On-Property Corrective Measures Implementation Construction Completion Report

Subject:
On-Property CMI Construction Documentation Report
Koppers Inc. Superior, Wisconsin Facility
WDNR BRRTs No: 0216000484
WDNR Facility ID: 816009810

**On-Property Corrective Measures
Implementation Construction
Documentation Report**

Koppers Inc. Facility
Superior, Wisconsin

FINAL GRADING PLAN - AREA B

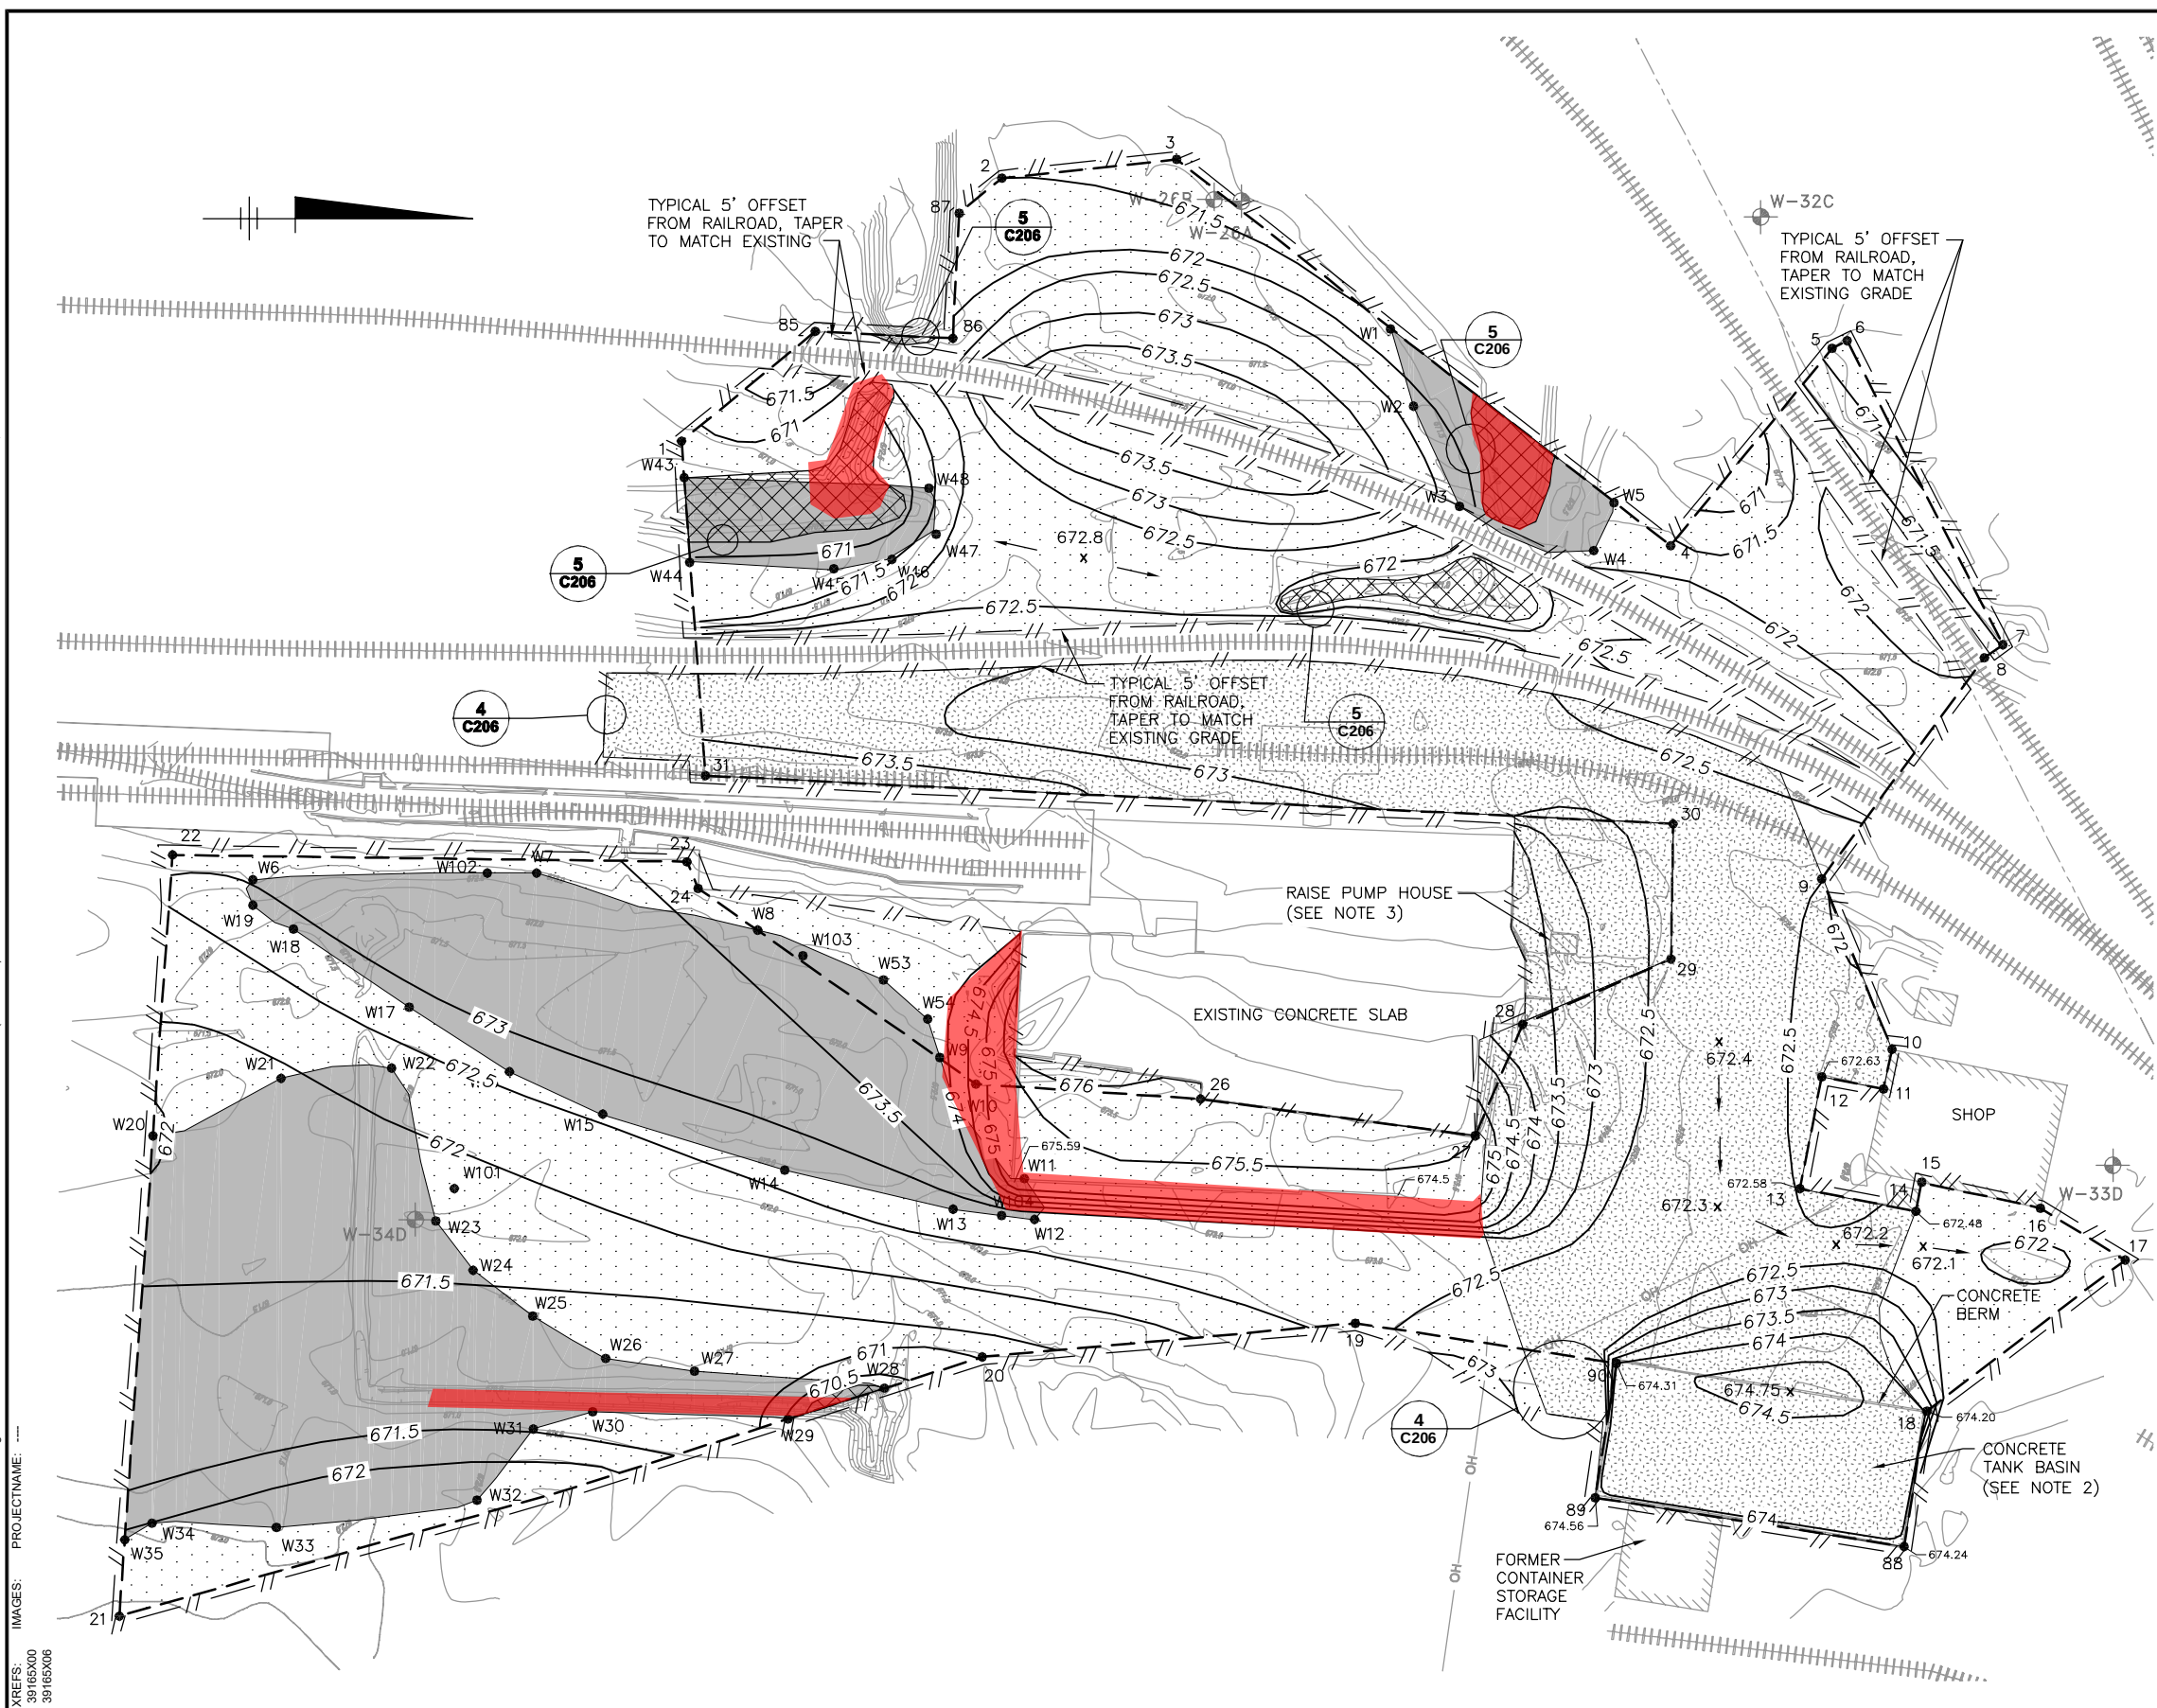
Attached is revised Contract Drawing C200 for the final revised grading plan for Area B based on the adjusted Limit of Grading to include the pump house building area and 2010 ground survey data¹.

Attached Contract Drawing C200 depicts the final Surface Cover Limits for Area B..

As noted on attached Contract Drawing C200, existing Surface Cover Limits 25 and 90 are within the revised surface cover, and the revised surface cover resulted in new Surface Cover Limits 100 through 106.
